Intel® Desktop Board D865PERL Specification Update

Release Date: August 2004

Order Number: C41596-009

Figure 29a. Omnidirectional Airflow Heatsink

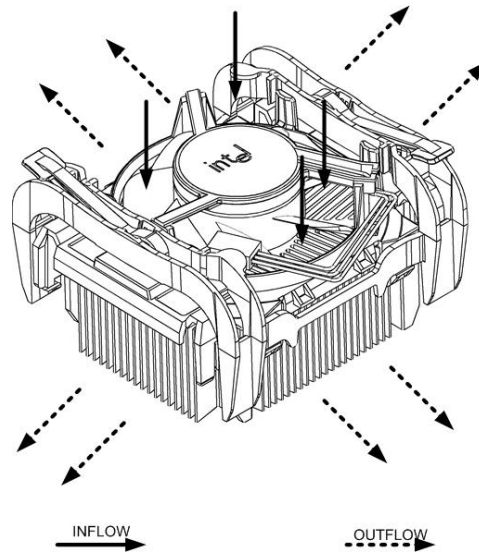
4. **Change to Thermal Considerations, Section 2.12**

Section 2.12, Thermal Considerations will change in its entirety as follows:

- *A chassis with a maximum internal ambient temperature of 38 Degrees Celsius*
- *A processor heatsink that provides omnidirectional airflow so that air is drawn across the processor voltage regulator area (item A in Figure 30). Figure 29a illustrates an omnidirectional airflow heatsink.*

Figure 30. Localized High Temperature Zones

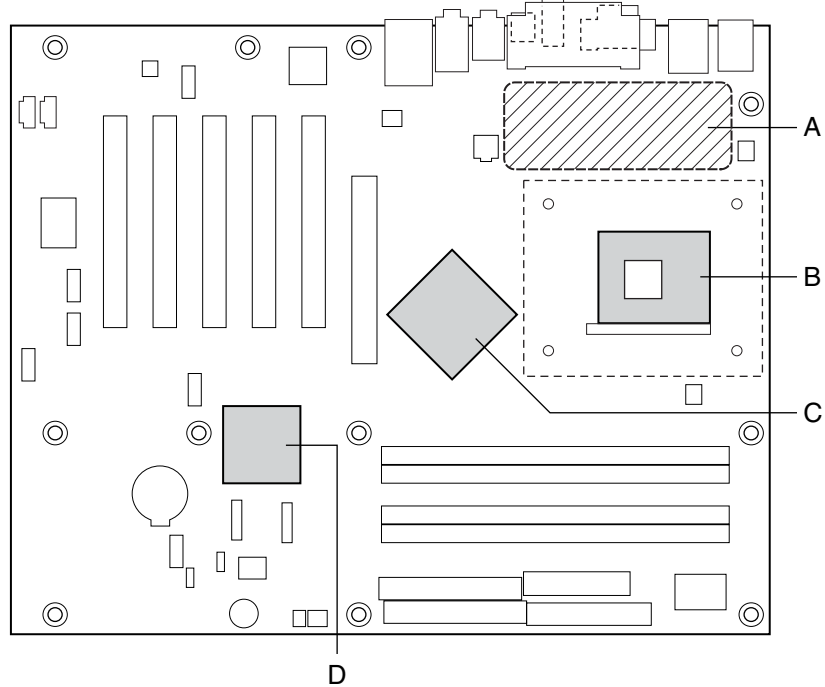
Ensure that proper airflow is maintained in the processor voltage regulator circuit. Failure to do so may result in damage to the voltage regulator circuit. The processor voltage regulator area (item A in Figure 30) can reach a temperature of up to 85 °C in an open chassis.

Figure 30 shows the locations of the localized high temperature zones.
